Watson & Chalin Manufacturing, Inc. ("W&C") has decided that a defect which relates to motor vehicle safety exists in a limited number of SL2065 20,000-pound rated capacity steerable auxiliary lift axle suspension systems. These SL2065 suspension systems were manufactured between November 13, 2019 and April 30, 2020.

## Pivot Fastener Notice

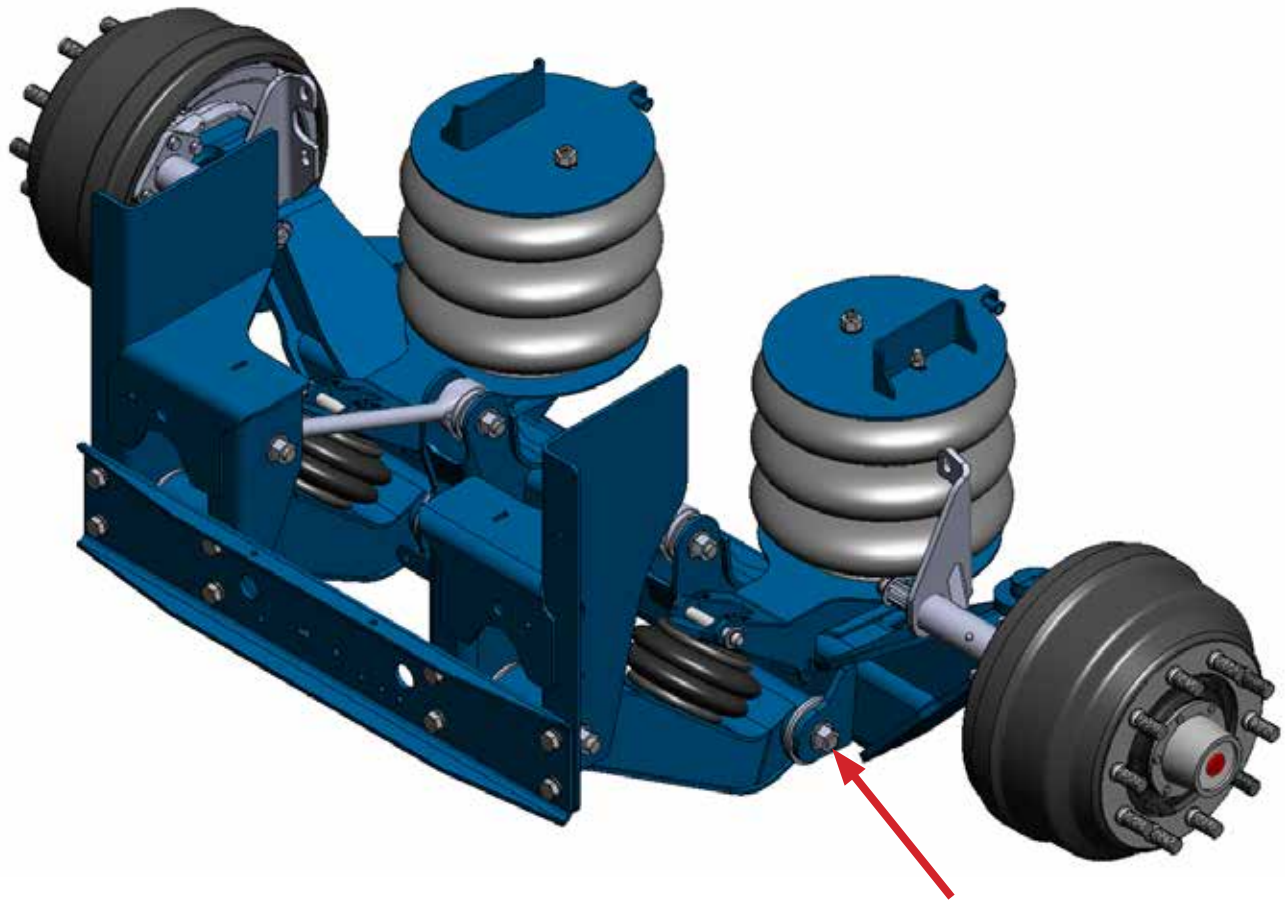
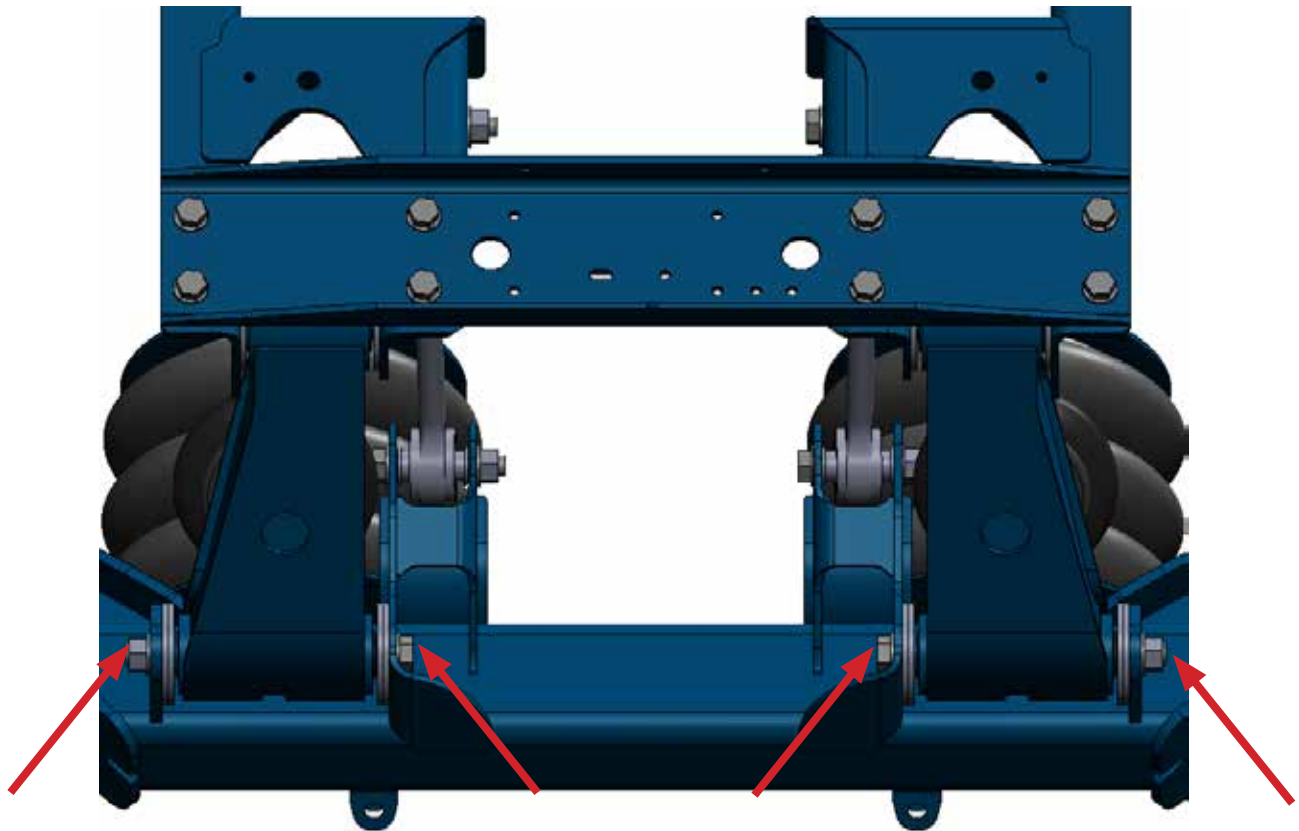
These suspensions may be equipped with lower rear pivot capscrews that are not long enough to sufficiently engage the locking feature of the corresponding nuts.

In some cases, this condition may cause a loss of clamp load of the corresponding pivot joint. Extended use of the suspension in this condition can result in the fracture or loss of the cap screw and related washers and nut. This can further result in foreign object debris on the roadway, increasing the risk of a crash and / or injury. W&C has not received any field reports of accidents due to a cap screw fracture or loss.

Possible warning signs that may appear before a lower rear pivot cap screw fracture or loss include an insufficient number of cap screw threads extending beyond the end of the pivot nut, a missing pivot nut, failure of the suspension to lift or lower properly, and suspension noise and vibration.

W&C recommends owners of any vehicles equipped with the above-referenced SL2065 suspension systems use W&C Technical Bulletin Number W&C263 (SL2065 Pivot Fastener Inspection) to inspect these suspension systems in the areas indicated by the red arrows in the above figure. The inspection is to include, once the fastener is properly tightened to the specified torque, determining whether the lower rear pivot cap screws meet minimum specified length requirements by measuring from the end of the capscrew to the top of the nut.

If the inspection finds any lower rear pivot cap screws that do not meet the minimum specified length requirements of 0.350 inch of capscrew extending beyond the top of the respective nuts, W&C recommends vehicle owners contact W&C to order a replacement lower rear pivot fastener hardware kit, W&C Part Number SRK2065WAR-001. The replacement fasteners should be installed using the instructions provided in W&C Technical Bulletin Number W&C264 (SL2065 Pivot Fastener Installation), also included in the replacement kit.

Any lower rear pivot cap screws that extend 0.350 inch or more beyond the top of the respective nuts, are properly tightened to the specified torque, contain no fractures, and otherwise appear to be in good condition can continue to be used in normal suspension operation.
